Access Compliance Report

Public Rights-of-Way

Intersection ID: 26999	Main Street: SETON_HOUSE_LN	Cross Street: SHEPHERDLEAS_LN	Location: NE
ADA ID: 0C0A9C61FF11	Ramp Type: PerpDiag	Initial Pass/Fail: Fail	Overall Compliance: No
Severity Score: 8.75			
Codes/Mitigation Info/Possible Solution		Field Measurements/Component Compliance

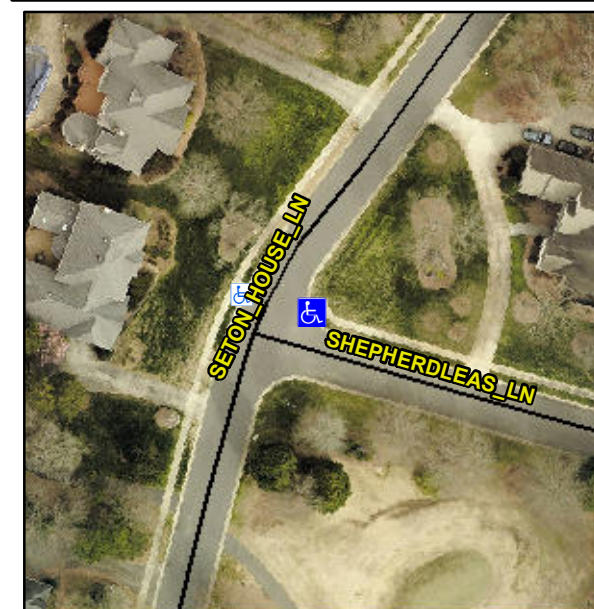
Compliance	Description	Data	Compliance	Description	Data
N/A	Ramp Length (in)	49.0	Yes	Ramp Slope (%)	6.4
No	Ramp Width (in)	36.5	Yes	Ramp XSlope (%)	0.7
N/A	Flare Type LT	N/A	N/A	Flare Type RT	N/A
N/A	Flare Slope LT (%)	N/A	N/A	Flare Slope RT (%)	N/A
N/A	Flare Traversable LT?	N/A	N/A	Flare Traversable RT?	N/A
N/A	Landing Length (in)	N/A	N/A	DWS Provided?	N/A
N/A	Landing Width (in)	N/A	N/A	DWS Contrast?	N/A
N/A	Landing Slope (%)	N/A	N/A	DWS Length (in)	N/A
N/A	Landing X Slope (%)	N/A	N/A	DWS Full Width?	N/A
N/A	Landing Curb? (Y/N)	N/A	N/A	DWS Offset (in)	N/A
N/A	Shared Landing?	N/A			
N/A	Gutter Ponding?	N/A	N/A	Gutter Slope (%)	N/A
N/A	Gutter Lip Ht (in)	N/A	N/A	Gutter X Slope (%)	N/A
N/A	Painted X Walk1?	No	N/A	Painted X Walk2?	No
	X Walk 1 Direction	To W		X Walk 2 Direction	To S
N/A	X Walk 1 Width (in)	N/A	N/A	X Walk 2 Width (in)	N/A
	X Walk 1 Slope (%)	7.8		X Walk 2 Slope (%)	5.5
	X Walk 1 X Slope (%)	2.2		X Walk 2 X Slope (%)	6.7

N/A	Ramp inside XWalk1?	N/A	N/A	Ramp inside XWalk2?	N/A
	Road Slope (%)	0.8	N/A	Clear Space?	N/A
	Road X Slope (%)	9.1	N/A	Clear Space to XWalk (in)	N/A
N/A	Any Obstructions?	N/A	N/A	Storm Grate/Utility Hazard?	N/A
	Obstruction Type			Storm Grate/Utility Type	
		N/A			N/A
		Yes		Surface Condition? (G/P)	Good

Remove & Replace Curb Ramp With Two New Directional Ramps or Equivalent.
